Town Creek Restoration Project – Option B Final Monitoring Report/Closeout Report

DMS Project ID Number – 95026; NC DEQ Contract No. 003990

Subject: Task 9: Annual Final Monitoring Report/Closeout Report – Monitoring Year 5 & Response to Comments
Town Creek Restoration Project – Option B
Yadkin River Basin – CU# 03040105 – Stanly County, NC
NCDMS Project ID No. 95026; NCDEQ Contract No. 003990

Permanent Cross-section
X4 Riffle - Reach 2
(Monitoring Year 5 - Collected September 2020)

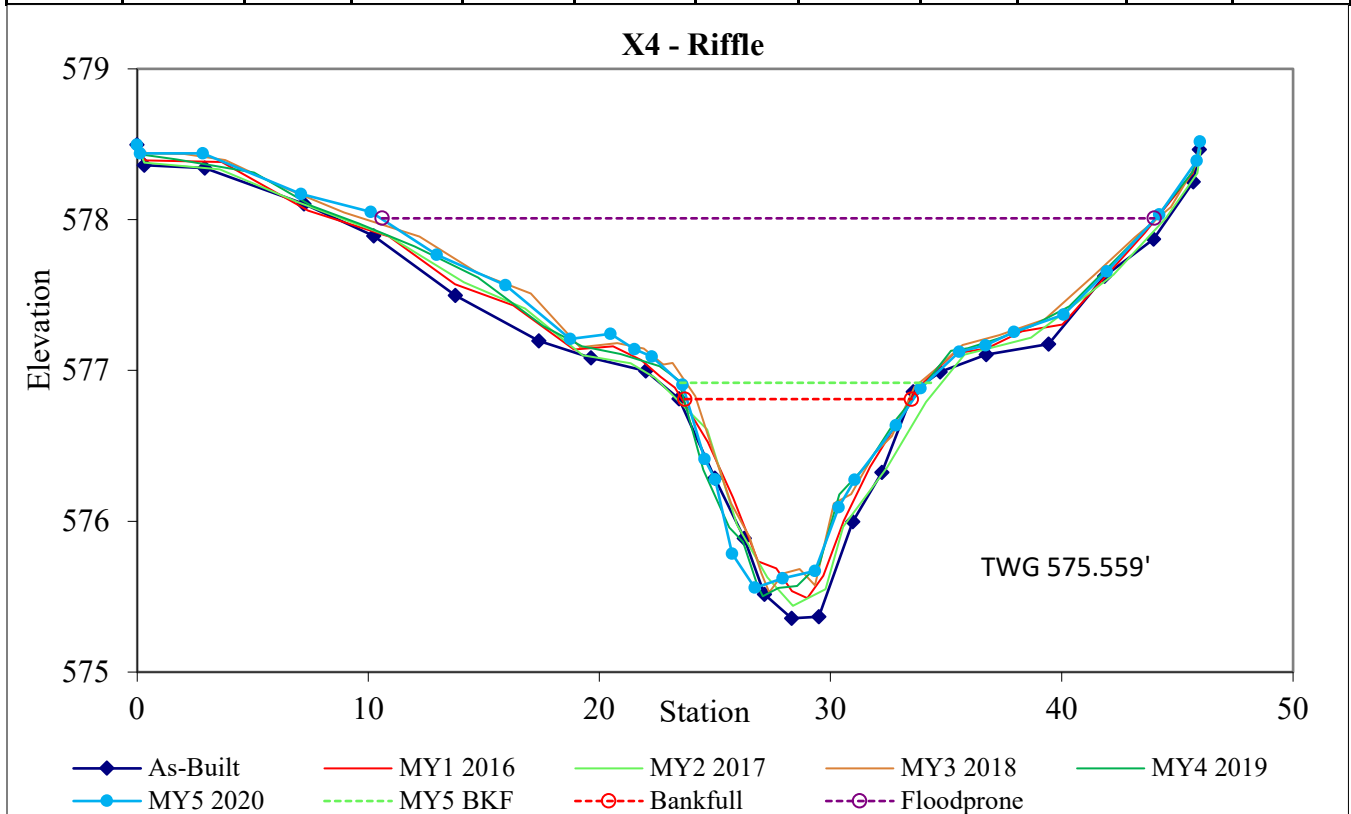
Comment - Please be sure that all BHR calculations are using MY5 data. For example, XS4 is using the MY4 LTOB elevation. When using the MY5 LTOB elevation, the BHR is 1.12. Please also ensure that any footnotes are updated to include the proper elevations.

Response – Revisions have been made per DMS request.
